September 9th, 2010

On behalf of the U.S. Nuclear Regulatory Commission (NRC), I am responding to your letters, dated April 8, 2010, to Chairman Gregory B. Jaczko and the Advisory Committee on Reactor Safeguards. In the letters, you expressed your general concerns with "Industry Standards in Licensed Operator Training," and your specific concerns with the NRC's Generic Fundamentals Examination (GFE) Question Bank. You also reiterated your specific concerns, initially provided to us in May 2006, regarding GFE Question P415. Again, I apologize for our failure to complete our response to the specific concerns that you raised in May 2006.

Staff Response to Comments Regarding Specific GFE Questions

Fig. 6

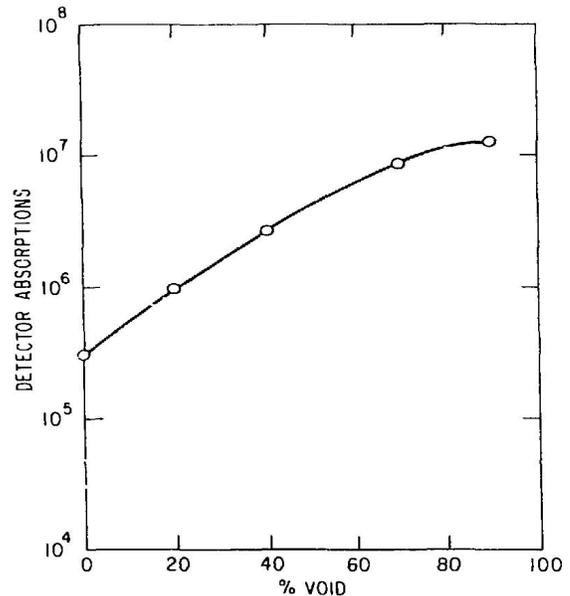
Discussion: An assertion is made that the posted answer for the above question is incorrect. The posted answer is supported by documentation from an authoritative source, although another document from the same source appears to support a different answer.

When the negative effects of decreasing photoneutron source strength and decreasing K_{eff} are combined, there is a total core neutron decrease factor of between 1.0×10^{-2} and 1.0×10^{-3} from complete homogeneous core voiding. When the effect of the increased neutron transmission probability is added, the rate of neutron detection by the SRDs is expected to increase by a factor of between 1.0×10^1 and 1.0×10^2 from complete homogeneous core voiding. This range is supported by figure 6 (below) from ANL-81-75.

The graph in figure 6 shows a curve that stops at about 90 percent core voiding. ANL-81-75 states that model calculations near 100 percent are not accurate and, therefore, are not plotted. ANL-81-75 goes on to state:

“Even though the neutron source strength is decreasing, the transmission probability (i.e., to the detector) is increasing at a greater rate. The result is a continually increasing count rate.”

It is important to note that ANL-81-75 begins its analysis no sooner than thirty minutes after a scram, when the photoneutron source strength is decreasing at a moderate rate. If the analysis had begun sooner, the photoneutron source strength would have been decreasing at a faster rate, and the SRD response would have been different. If the analysis had begun immediately after a scram, it is possible that the SRD response would have decreased initially due to the high rate of decay of the photoneutron source strength.

There are several reasons why the findings in ANL-81-75 are not directly applicable to P415:

Summary and Conclusion: Two Westinghouse MCD texts with different publishing dates -- 1983 and 1991 -- differ in their descriptions of excore SRD response to homogeneous core voiding. Each text supports a different answer to GFE question P415.

Conclusion: Presently, a single definitive correct answer for P415 has not been determined. Therefore, P415, and similarly affected questions, will be removed from the GFE question banks.

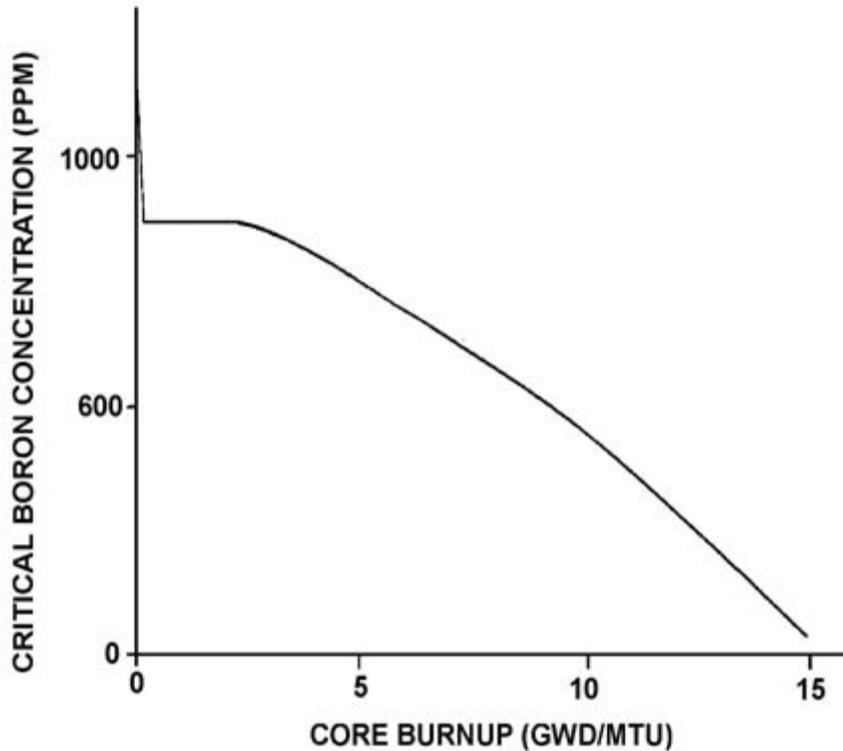
Discussion: An assertion is made that PWR critical boron curves provided in the GFE bank questions represent older core designs (prior to 1990) instead of modern cores (1990 and later). The staff acknowledges that reactor core designs have changed over time and therefore have different critical boron curves over time. However, the overall shape of the curves from the middle of core life to the end of core life has not changed. Furthermore, the GFE is a generic fundamentals examination and is not designed to test site-specific knowledge. The NRC finds that, as written, this question examines the fundamental concepts of critical boron concentration throughout core life and is therefore appropriate for the GFE exam.

Discussion: An assertion is made that PWR critical boron curves “show a rise in boron concentration shortly after the compensating drop that accounts for initial Xenon-135 buildup.” As discussed above, the staff acknowledges that reactor core designs have changed over time and therefore have different critical boron curves over time. However, the overall shape of the curves early in core life are still “relatively constant.” The NRC finds that, as written, this question properly examines a fundamental concept of critical boron concentration early in core life that is still valid.

Conclusion: P1563 will remain in the GFE question bank.

Conclusion: P1864 will remain in the GFE question bank.
